## FIELD ADVISORY

FA#98-003 January 10, 1998

SUBJECT: Installation and Modifications for new U801 prescaler in LTR® 86xx series

Mobiles

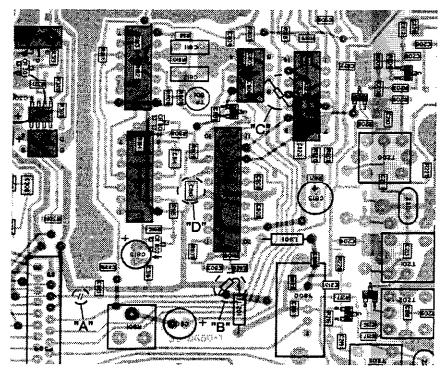
- 3. Insert new U801 into board
- 4. Cut the trace at point marked "A" shown in Figure 1 on the back of this page.
- 5. Remove solder from the feed-through pads shown at point "B" in Figure 1 on the back of this page.

- 6. Add a 569-0115-101 chip resistor to the two pads shown at point "B" in Figure 1 on the back for this page.
- 7. Remove C809 on all units except 8655's (C810 on 8655 only), shown at point "D" in Figure 1 on the back of this page, being careful not to damage the pads.

- 8. Install a 510-2625-229 capacitor in C809's position (C810 on 8655 only).
- Install a 510-3554-104 capacitor from pin 7 of U801 to pin 10 of U803 shown at point "C" in Figure 1 on the back of this page.
